UNITED STATES  
NUCLEAR REGULATORY COMMISSION  
WASHINGTON, D. C. 20555

SUBJECT: AMENDMENT NO. 112 TO PROVISIONAL OPERATING LICENSE NO. DPR-20: STEAM GENERATOR AUGMENTED INSERVICE INSPECTION PROGRAM (TAC NO. 56365)

PALISADES PLANT

SAFETY EVALUATION BY THE OFFICE OF NUCLEAR REACTOR REGULATION

FIGURE 4.14.1 - SUPPLEMENTARY SAMPLING FLOW CHART

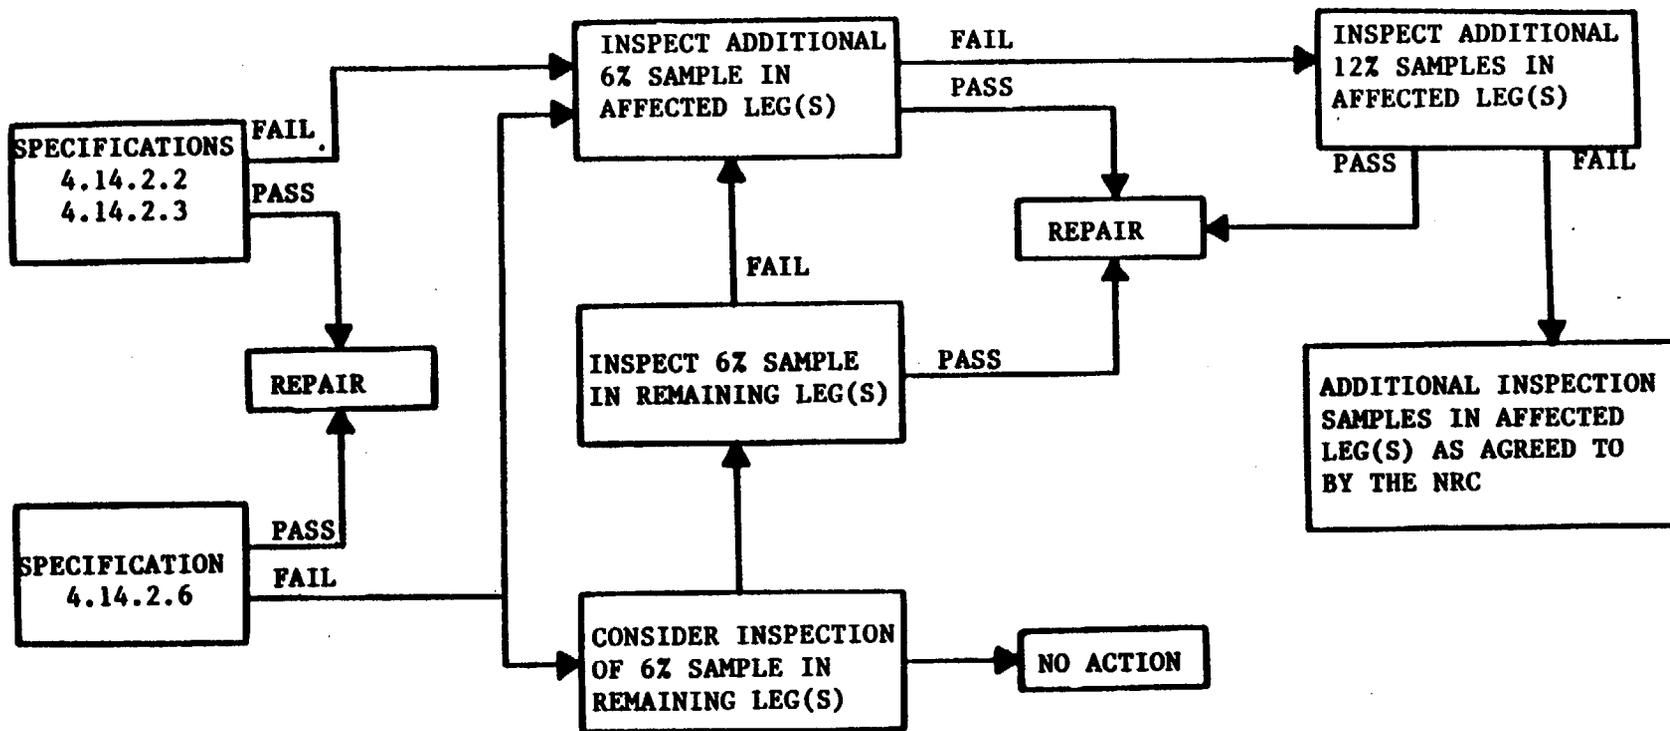
This section adds a proposed new requirement; namely should initial inspection sampling in accordance with Sections 4.14.2.2, 4.14.2.3, or 4.14.2.6 yield results exceeding one or more of the following criteria, then supplementary samples of unplugged tubes shall be inspected in accordance with Figure 4.14.1.

- a) More than 10% of the inspected tubes in a leg have detectable wall degradation (greater than or equal to 30% through wall) where no previous degradation was detected.
- b) More than 10% of the inspected tubes in a leg exhibit further wall degradation (greater than a 10% increase in through wall degradation).
- c) More than 1% of the inspected tubes in a leg have indications of tube wall degradation in excess of the repair criteria of Specification 4.14.4 where no wall degradation greater than 30% was detected in the previous two inspections.

In the event that one or more of the above criteria are exceeded during initial inspection sampling, Figure 4.14.1 would require that an additional 6% sample of tubes be inspected. If the results of the second sample exceed the above criteria, then an additional 12% sample would have to be inspected. If the results of this third sample exceed the above criteria, then additional inspection samples must be performed as agreed to by the NRC.

The current Technical Specifications for Palisades contain no requirements for supplementary sample inspections. The supplementary sampling requirements now being proposed are still less stringent than what is specified in the Technical Specifications for virtually all other plants. The staff finds this not to pose any immediate concern since corrosion degradation has been largely arrested since the 1970s. Given the current status of corrosion degradation in the Palisades steam generators the staff believes the Technical Specification

The above comments notwithstanding, the proposed supplementary sampling requirements in Section 4.14.3.1 represent an upgrade of existing requirements and are therefore acceptable to the staff.
